# REPORT SUMMARY MINOR VARIANCE APPLICATION FILE NUMBER A135/24

Report Date: November 8, 2024

CITY WARD #:	5
APPLICANT:	Monica Murad
AGENT:	Martin Rendl
PROPERTY:	15 Mill Street, Thornhill
ZONING DESIGNATION:	See below.
VAUGHAN OFFICIAL PLAN	Vaughan Official Plan 2010 ('VOP 2010'): "Natural Areas"
(2010) DESIGNATION:	
RELATED DEVELOPMENT	None
APPLICATIONS:	
PURPOSE OF APPLICATION:	Relief from the Zoning By-law is being requested to permit the
	construction of a proposed new two storey coach house (which will
	replace the existing one-storey coach house).
	The new coach house is located in the southeast part of the property
	and will be an addition attached to the existing dwelling. The new
	coach house will contain a secondary suite as an accessory dwelling
	unit.

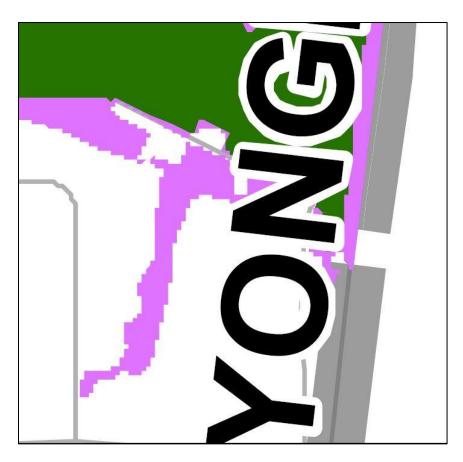
- Based on this extract from Schedule 1 Urban Structure, the property appears to fall within the Local Centres and perhaps a portion of the Community Areas designation as well. The generally straight boundary between the Natural Areas and Countryside designation and the Local Centres designation likely corresponds with a man made feature like Mill Street or existing lots which are often used as the boundary between land use designations.
- The Natural Areas and Countryside designation appears to be the river valley located north of the both the property and of the residential lots on the north side of Mill Street given that the Official Plan describes Natural Areas as including the valley of the Don River.

- Policy 10.2.1.6 of the Vaughan Official Plan provides direction on interpreting the boundaries of its land use designations. It states that the boundaries of land use designations will be determined by a review of existing zoning by-laws; prevailing lot depths; orientation of lot frontages; lot patterns; and land use patterns.
- that regard, these In extracts from the Zoning Bylaw show the lands in the area zoned for Residential uses (R1E) and those zoned for Open Space (OS) or Environmental Protection Area (EP). The zoning by-law and prevailing patterns of developed lots and land helpful uses are identifying the boundaries of the general land use designations of the Official Plan.

- The application is located within the Urban River Valley of the Greenbelt Plan.
  - Policy 6.2.1 of the Greenbelt Plan states only publicly owned lands within the Urban River Valley are subject to the Urban River Valleys policies of the Greenbelt Plan. Any privately owned lands within the Urban River Valley area are not subject to the policies of the designation.

15 Mill Street Site Plan & Location of Setback Variances #1 & #2

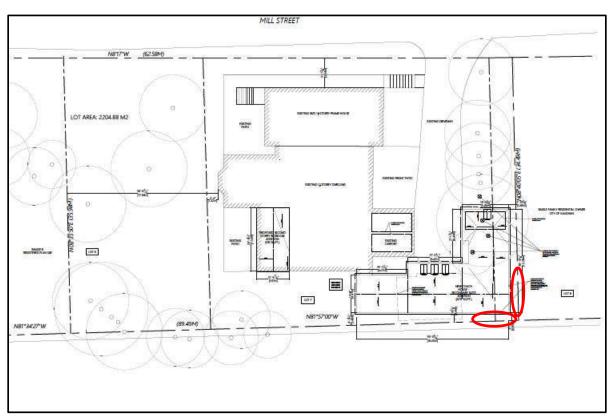
As the site plan below shows, the setback variances apply to the setbacks of the proposed new coach house from the south and east lot lines at the south east corner of the property.
